Service Bulletin

SB 30-7
8/10/87

PRODUCTION CHANGE /
SCHEDA INTRODUZIONE VARIANTE

SUBJECT / OGGETTO: INPUT SHAFT
VEHICLES / VETTURE TIPO: 412 (Manual Transmission)

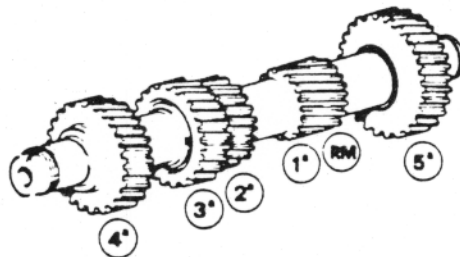
A modified input shaft (with 5th gear inserted and not integral as before) has been introduced.

Different manufacturing process.

OLD PART NO. / PARTICOLARI SOSTITUITI			NEW PART NO. / NUOVI PARTICOLARI		
Fig.	P. Number Disegno	Description / Denominazione	Fig. Rif.	P. Number Disegno	Description / Nuovi Particolari
1	119840	Input shaft	1	131865	Input shaft

The old and new parts are interchangeable.
